Access Compliance Report

Public Rights-of-Way

Intersection ID: 49297	Main Street: CAMPBELL_HALL_CT	Cross Street: CHAMBERLIN_RD	Location: SW
ADA ID: BC28013DA509	Ramp Type: Perp	Initial Pass/Fail: Fail	Overall Compliance: No
Severity Score: 26.25			
Codes/Mitigation Info/Possible Solution		Field Measurements/Component Compliance

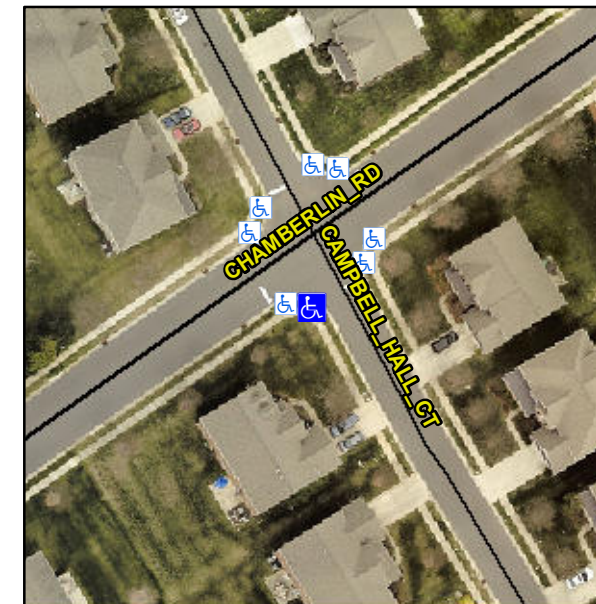
Not Found, R304.2.2, R304.5.3

Compliance	Description	Data	Compliance	Description	Data
N/A	Ramp Length (in)	48.0	No	Ramp Slope (%)	16.4
Yes	Ramp Width (in)	48.0	No	Ramp XSlope (%)	2.8
N/A	Flare Type LT	N/A	N/A	Flare Type RT	N/A
N/A	Flare Slope LT (%)	N/A	N/A	Flare Slope RT (%)	N/A
N/A	Flare Traversable LT?	N/A	N/A	Flare Traversable RT?	N/A
N/A	Landing Length (in)	N/A	N/A	DWS Provided?	N/A
N/A	Landing Width (in)	N/A	N/A	DWS Contrast?	N/A
N/A	Landing Slope (%)	N/A	N/A	DWS Length (in)	N/A
N/A	Landing X Slope (%)	N/A	N/A	DWS Full Width?	N/A
N/A	Landing Curb? (Y/N)	N/A	N/A	DWS Offset (in)	N/A
N/A	Shared Landing?	N/A			
N/A	Gutter Ponding?	N/A	N/A	Gutter Slope (%)	N/A
N/A	Gutter Lip Ht (in)	N/A	N/A	Gutter X Slope (%)	N/A
N/A	Painted X Walk1?	No	N/A	Painted X Walk2?	N/A
	X Walk 1 Direction	To NE		X Walk 2 Direction	N/A
N/A	X Walk 1 Width (in)	N/A	N/A	X Walk 2 Width (in)	N/A
	X Walk 1 Slope (%)	0.1		X Walk 2 Slope (%)	N/A
	X Walk 1 X Slope (%)	2.5		X Walk 2 X Slope (%)	N/A

Remove & Replace Entire Ramp.
